## Application for Licence Amendment

<b>Licence Number</b>	L5029/1992/11
<b>Licence Holder</b>	Northern Star (Kanowna) Pty Limited
<b>ACN</b>	010 511 789
<b>DWER references</b>	INS-0001176 APP-0030731
<b>Premises</b>	Kanowna Belle Gold Mine  Mining Tenements M27/18, M27/22, M27/23, M27/37, M27/49, M27/57, M27/92, M27/103, M27/122, M27/123, M27/127, M27/159, M27/164, M27/232, M27/245, M27/287, M27/420, L27/62, L27/83 and L27/87  As defined in Schedule 1
<b>Date of Report</b>	12/03/2026
<b>Status of report</b>	Final

This Amendment Report documents the assessment of potential risks to the environment and public health from proposed changes to the emissions and discharges during the installation and operation of an ultra-fine regrind circuit, paste plant and mobile screen plant, and the use of a new wastewater emissions point at the Premises. As a result of this assessment, Revised Licence L5029 has been granted.

**Figure 2: Depth to groundwater in monitoring bores distal to TSF1**

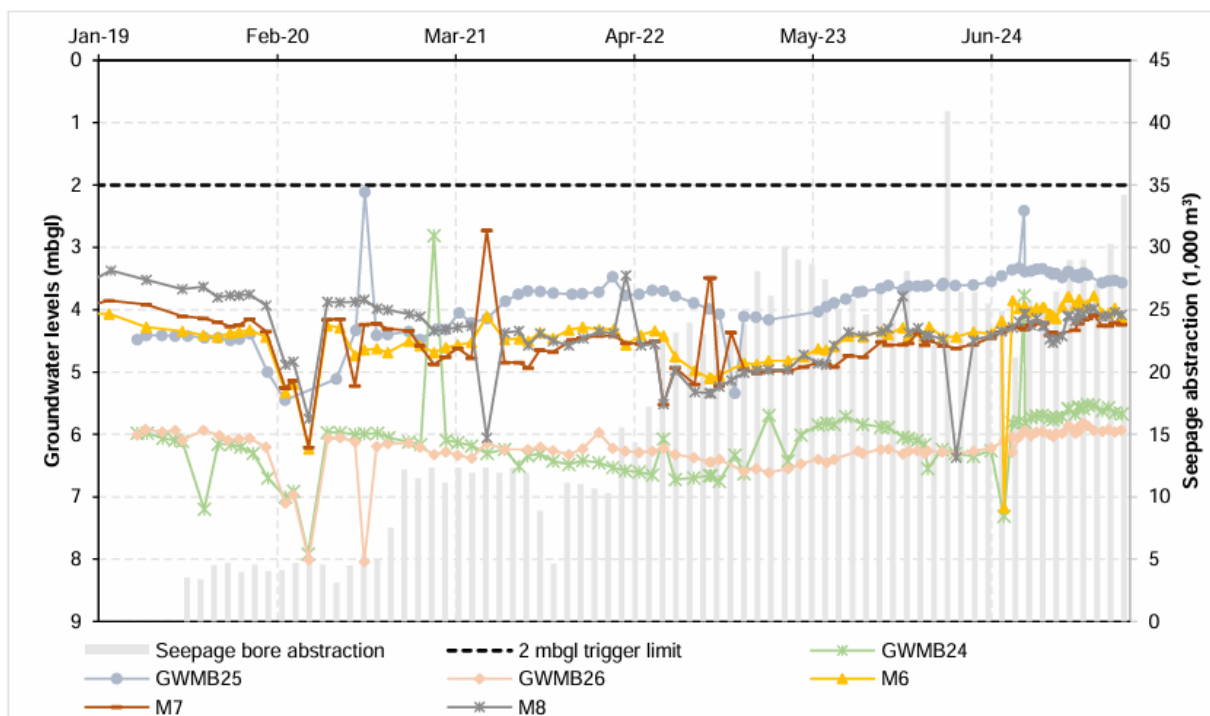
A review of the SWL data over the past 6 years of distal bores surrounding TSF1 identified limited occurrences when the SWL came close to triggering the reporting requirement of Condition 40 (see Figure 2 below).

The Delegated Officer acknowledges there are limited occurrences and bores where the SWL was identified at less than 2mbgl. Additionally, the Licence Holders proposed management which include abstraction of seepage water from the TSF1/TSF2 seepage management bore network for disposal into the Northwest Lead Pit is likely to result in lowering the SWL at the distal bores. Based on this, the Delegated Officer considers the Licence Holders request to change the reporting exceedances of SWL for TSF1 and TSF2 distal bores are reported retrospectively to the department in the Quarterly Groundwater Reports is acceptable as it is unlikely to increase the risk profile of the Premises.

Figure 4: Depth to groundwater in Red Hill monitoring bores (6 and 10m bgl trigger)

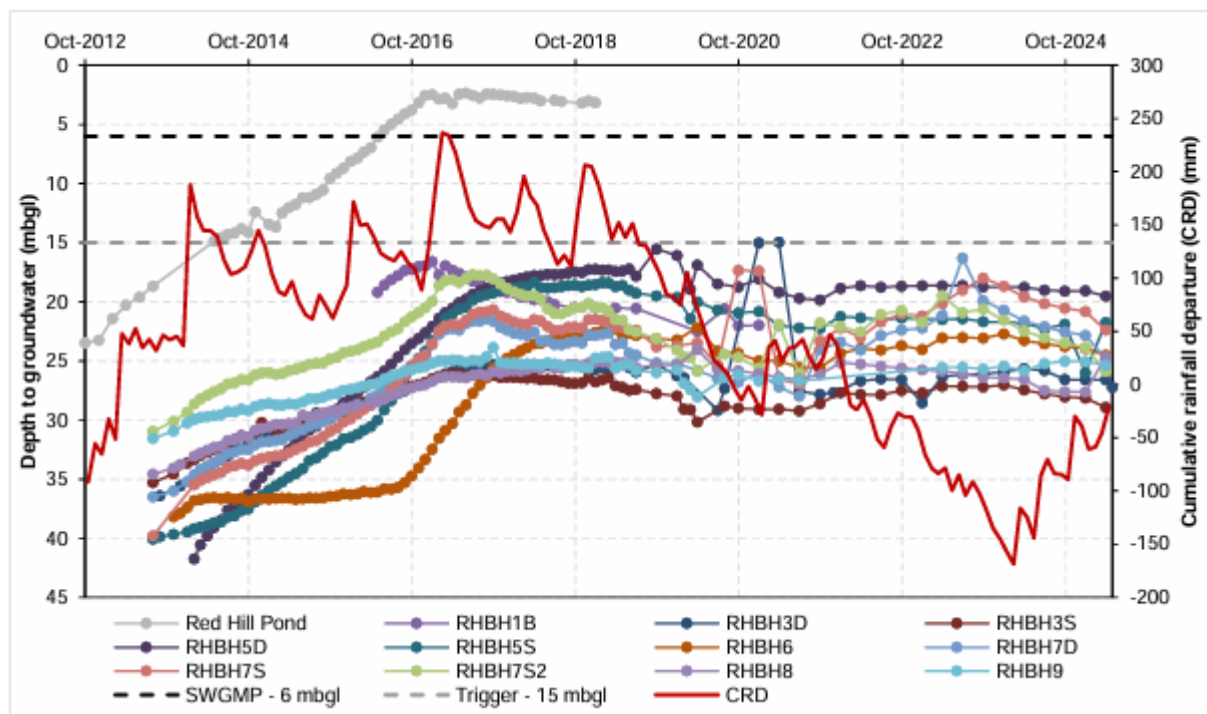
A review of the past 13 years of SWL data of the Red Hill In-pit groundwater monitoring bores indicates a stable or increasing depth over the past 6 years and has rarely been identified at a depth of less than 15m bgl. (see Figures 4 and 5 below).

The licence holder has voluntarily used triggers of 6 and 15m bgl for groundwater monitoring wells at both the Red Hill pit and the Waldon pit. However, these voluntary triggers have been rarely exceeded. The Delegated Officer considers the proposed reduced frequency of monitoring from quarterly to biannual monitoring does not significantly increase the risk to the local environment. As a result, the Delegated Officer has included a reduced sampling frequency for the Red Hill and the Waldon Inpit groundwater monitoring bores.

Figure 6: Depth to groundwater in Waldon monitoring bores west of the pit (6 and 15m bgl trigger)

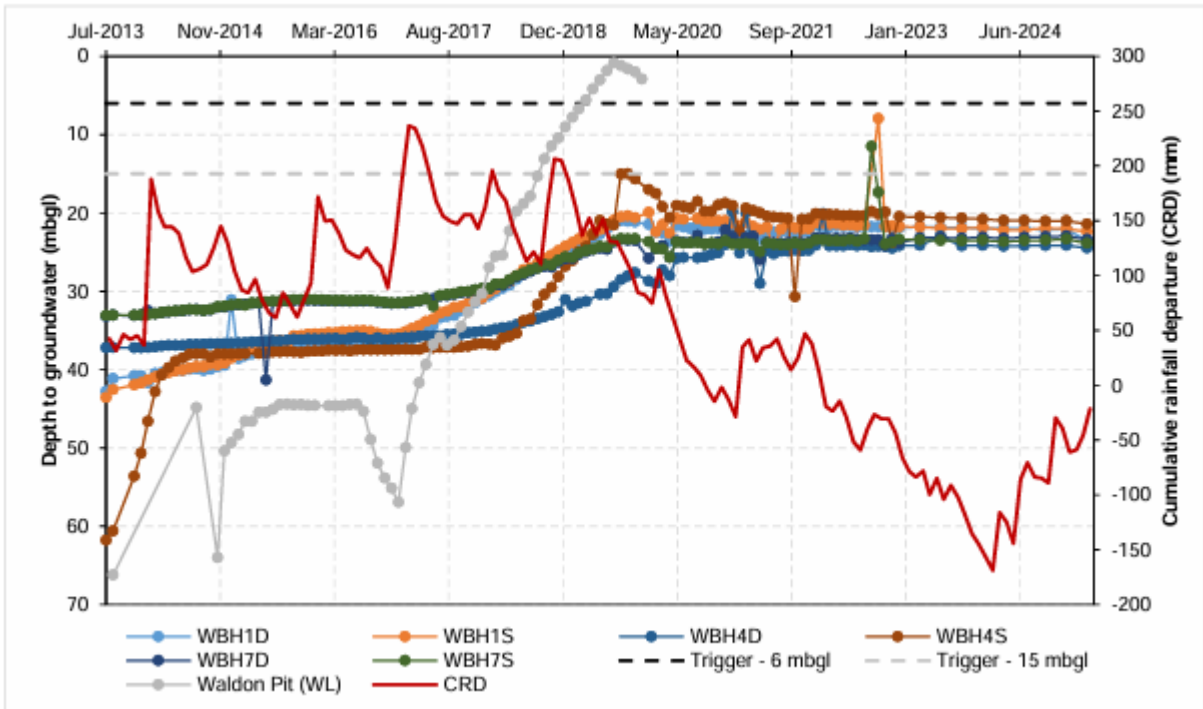
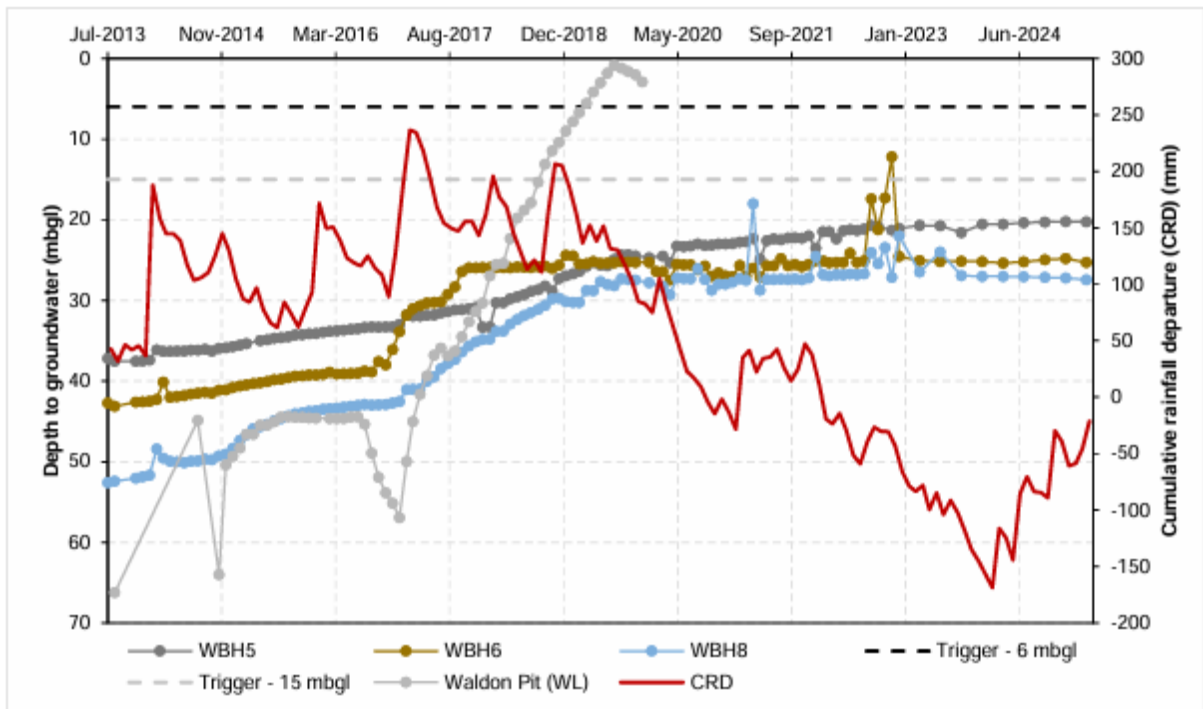
A review of the past 12 years of SWL data of the Waldon In-pit groundwater monitoring bores indicates a stable depth over the past 6 years and has rarely been identified at a depth of less than 15m bgl. (see Figures 6 and 7 below).

Figure 8: Depth to groundwater in the BLC groundwater monitoring bores

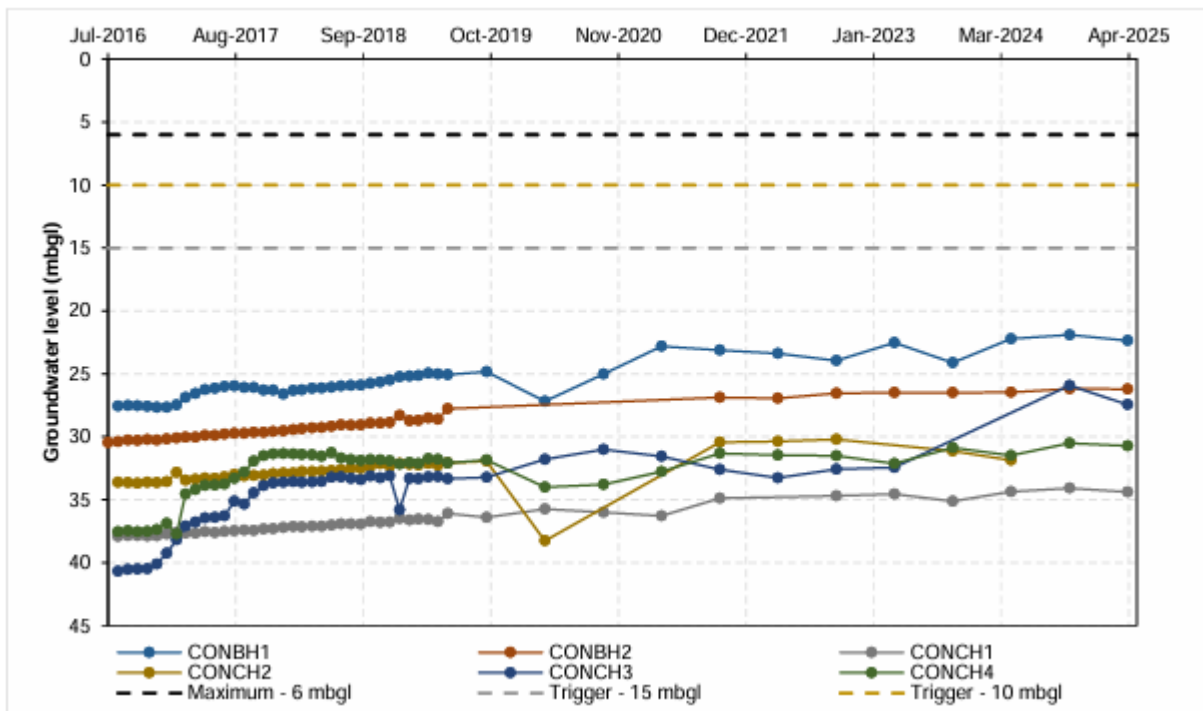
A review of the SWL data over the past 9 years of BLC and Consols groundwater monitoring bores indicates a stable trend over the past 6 years and has never been identified at a depth of less than 15m bgl therefore not triggering the requirements of Condition 24. (see Figures 8 and 9 below).

As the depth to groundwater has never exceeded the 'Action levels' of 6, 10 and 15m bgl in Condition 24 of the licence, the Delegated Officer considers the proposed reduced frequency of monitoring from biannual to annual monitoring does not significantly increase the risk profile of the Premises. As a result, the Delegated Officer has included a reduced sampling frequency for the BLC and Consols groundwater monitoring bores from biannual to annual.
